UNITED STATES PATENT AND TRADEMARK OFFICE

Office Action Summary	Application No. 10/679,469	Applicant(s) CONNELLY ET AL.	
	Examiner Timothy M. Ayres	Art Unit 3637

This is a first office action on the merits of application SN 10/679,469.

Jensen '563 Figure 4

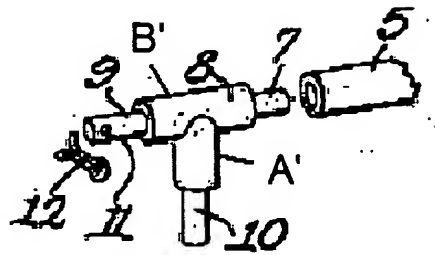
20. Claim 1 is rejected under 35 U.S.C. 102(b) as being clearly anticipated by U.S. Patent 589,563 to Jensen. Jensen '563 discloses a tent with a play area is the area/space inside a first perimeter defined by the wall-strips (j) that wrap around vertical columns (d). The outer edges of the canopy flaps (i) create a second perimeter. The second perimeter being larger than the first as seen in figure 1.
